## Field Review of Sammamish River Weir & Transition Zone – September 2011

Martin Nizlek, Ph.D. Civil Eng.

**Sammamish River Weir Looking West – Sept. 14, 2011**

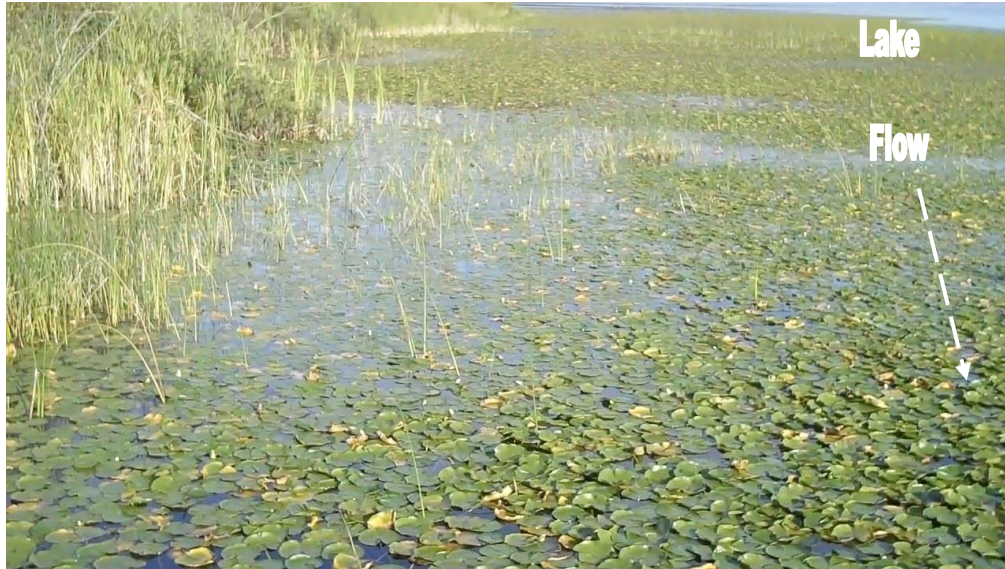
The weir proper, shown below, was slightly submerged. The area below the weir was pooled and it could be noted that the main channel heights were still distinctly higher than the top of the weir as observed in Sept. of 2010.

### **Sammamish River Transition Zone, 2007 Flood Conditions**

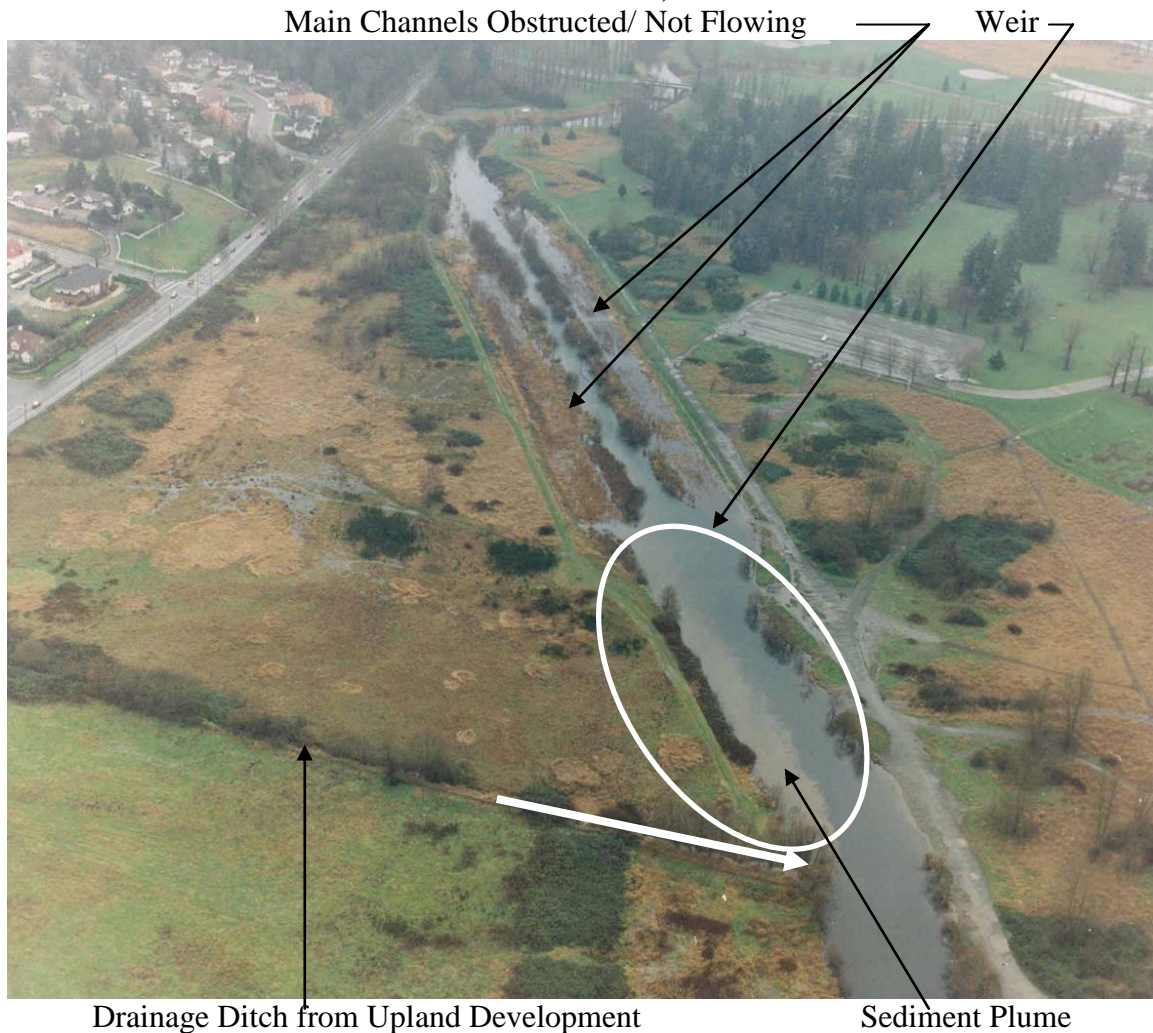
In addition, one or more drainage ditches dump storm water to the river ahead of the weir. The following photo, from a 2007 County document, clearly depicts this issue. A plume of sediment is readily discernible in this photo. It is likely that significant amounts of sediment have accumulated in the river bed, again reducing the cross section available to flow.

## Low Flow Channel Rock Obstruction – Sept. 2011

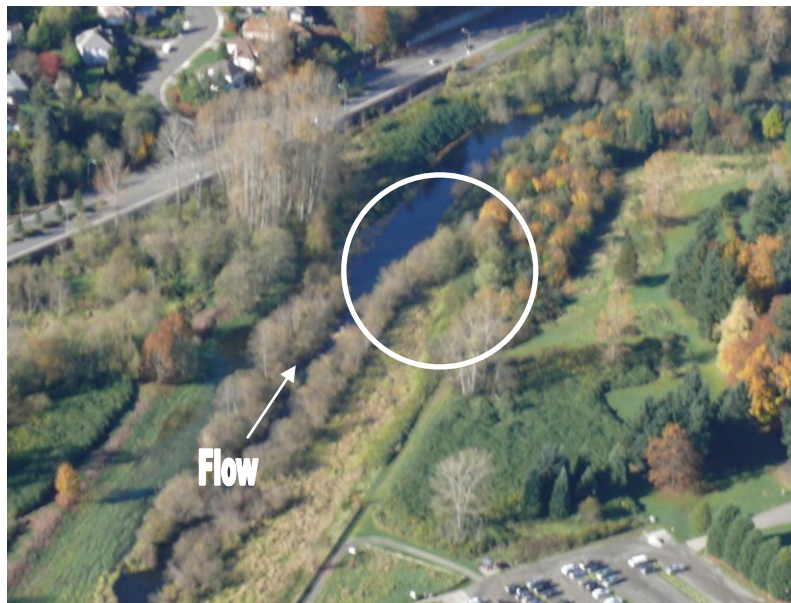
A rock obstruction was noted in the center, low-flow channel during the field visit. Shown in the following County photo, it too impedes flow. This is demonstrated by the pooling of water upstream of the obstruction. Placement of anything that blocks the flow of the active floodway (especially in-water placement) is typically prohibited without permits and a NMFS determination<sup>1</sup>. It is unclear who placed the rocks or why the rocks were placed in the water of the Sammamish River (in the bed of the active channel) or what permits were issued to allow this placement. This will impact channel flow and ultimately the water levels of Lake Sammamish. This rock obstruction will also impact the navigability of the river. If allowed to remain, it will pose safety risks to unsuspecting boaters.

The impacts of the obstruction can also be subtle. As noted in the photo below, and can be seen in aerial photos of the channel, the channel itself has been altered as water flowing through the area has sought out and cut new routes in the channel embankment. Such irregularities are much less efficient at moving flow. Discussion with County staff reveals the rock used for this small dam may be from the quarry spalls installed by the Corps' original project. Thus, the channel bed may have been compromised.

The County has performed the first of several actions promised to lake residents in April 2011. The main flow channels have been cut and raked and the center low flow channel willows have been trimmed. This trimming revealed a small dam of rocks which, according to WDFW may have existed since 2005. It should be removed.
